**Landscape Review Committee**  
**Community Development Center, 231 NE 5<sup>th</sup> Street**  
**July 17, 2019**  
**12:00 PM**

DATE: July 17, 2019  
TO: Landscape Review Committee Members  
FROM: Jamie Fleckenstein, Associate Planner  
SUBJECT: Landscape Plan Revision Application (L 22-02)

This is the consideration of a revision to an approved landscape plan (L 22-02) for the Dutch Bros. coffee stand at Citizen's Bank. The applicant is requesting to remove five trees from the landscape plan as they have struggled with finding a tree that will grow in this space after planting two different species of trees over the past fifteen years only to have them die and have to be removed.

***Figure 2: Applicant's Proposed Site Plan***

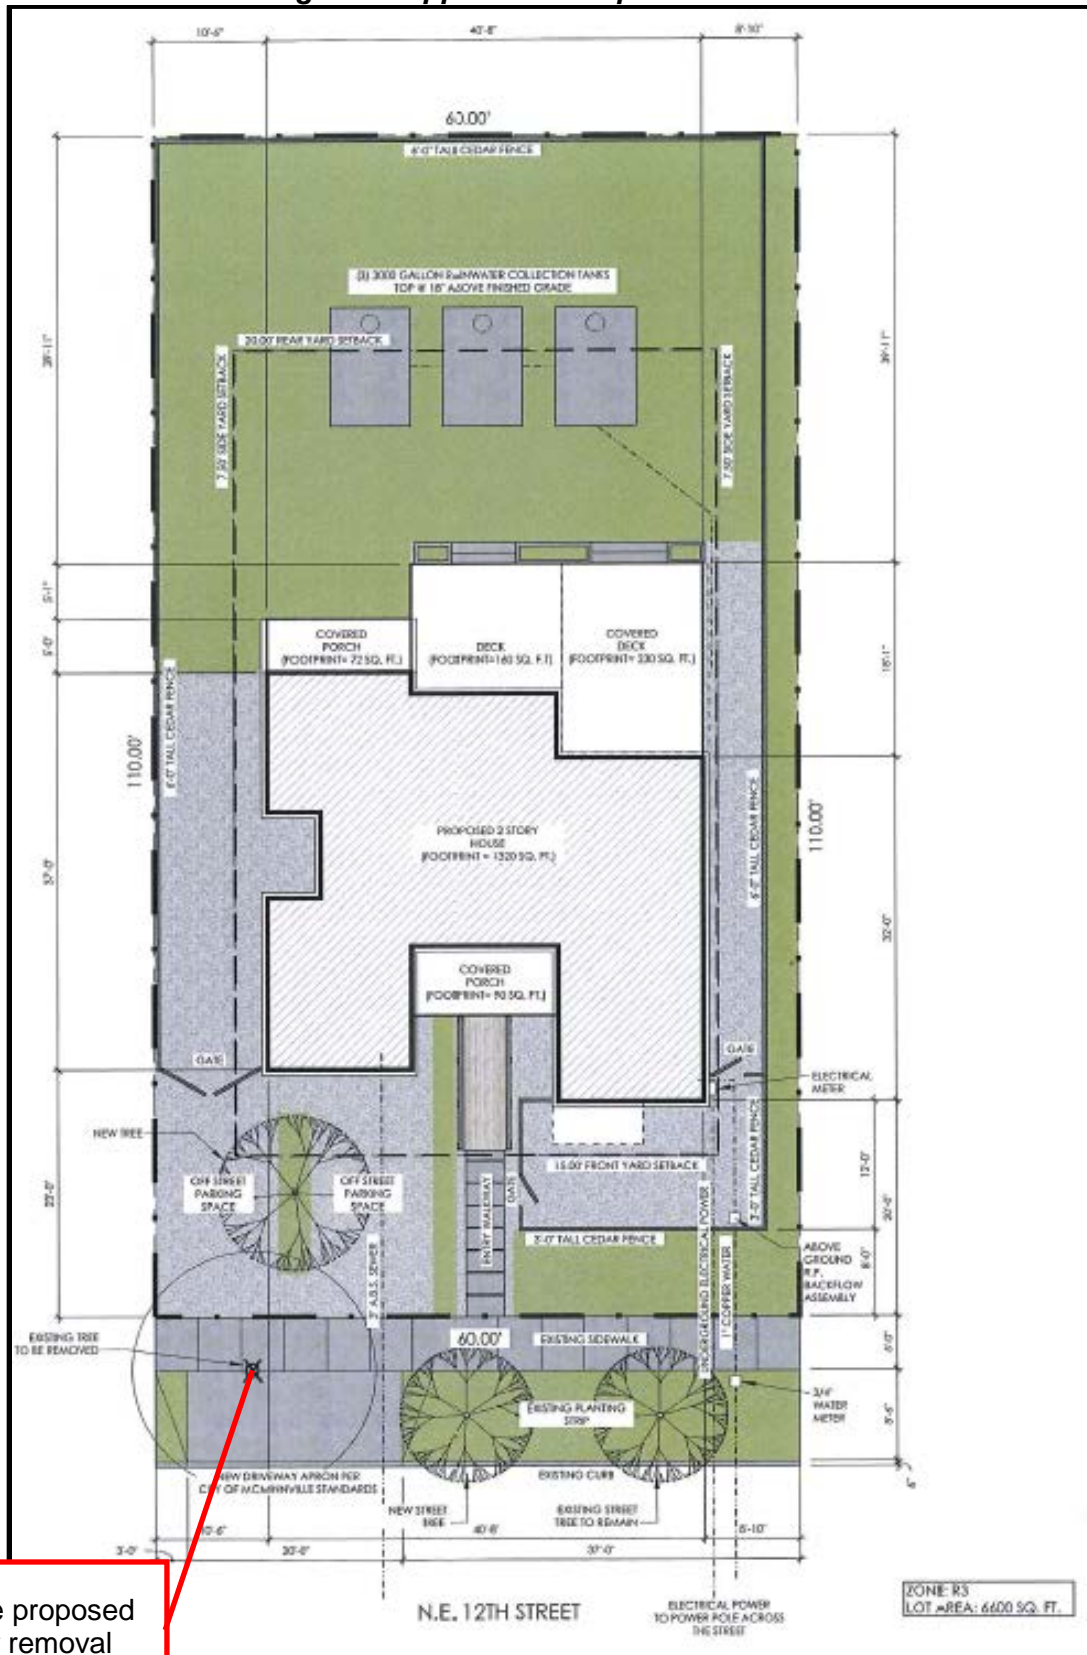
the development proposal is locating a new driveway curb-cut to access the property from NE 12<sup>th</sup> Street, where no curb-cut exists now. ***See Figure 2 (Applicant's Proposed Site Plan).***

The proposed development plan (**See Figure 2 (Applicant's Proposed Site Plan)**) indicates that a replacement street tree is proposed for the planter strip adjacent to the new driveway. Additionally, a second tree is proposed on private property breaking up the off-street parking spaces for the new residence. Given the sufficient space in the planter strip between the proposed driveway approach and the adjacent street tree, and spacing from public improvements and utilities, staff is recommending a replacement tree be required. No approved street tree plan is on file with the Planning Department for this subdivision. A tree from the McMinnville Street Tree List - Recommended Medium Tree Species, or other tree approved by the Landscape Review Committee, would be appropriate for a replacement tree, and consistent with other similar sized street trees along NE 12th Street.

**Figure 3: Proposed Site Plan**

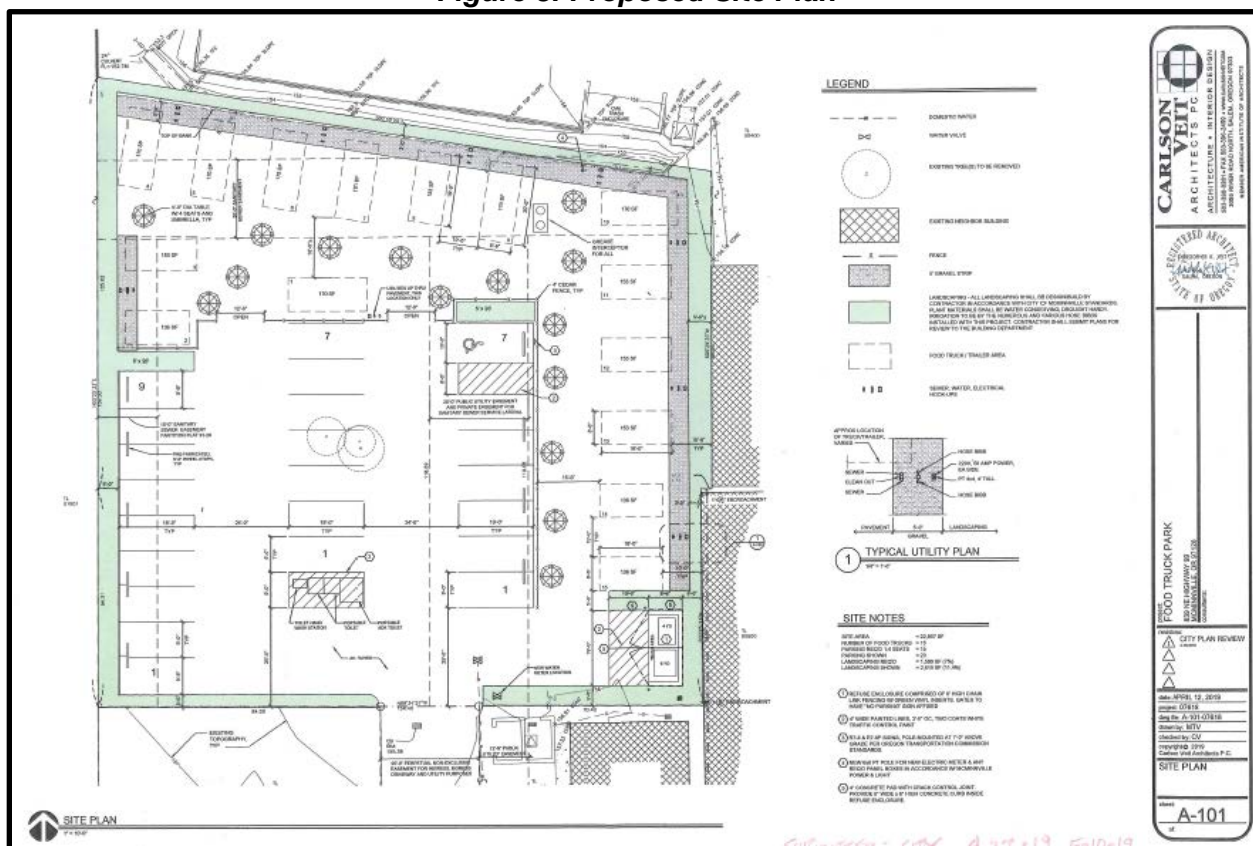
A building permit has been applied for to complete the buildout of the site by adding utilities and paving to accommodate 15 food trucks, off-street parking, and outdoor customer seating. **See Figure 3 (Site Plan).** The proposed landscape plan addresses required landscaping for commercial development per the McMinnville Zoning Ordinance. **See Figure 4 (Landscape Plan).**
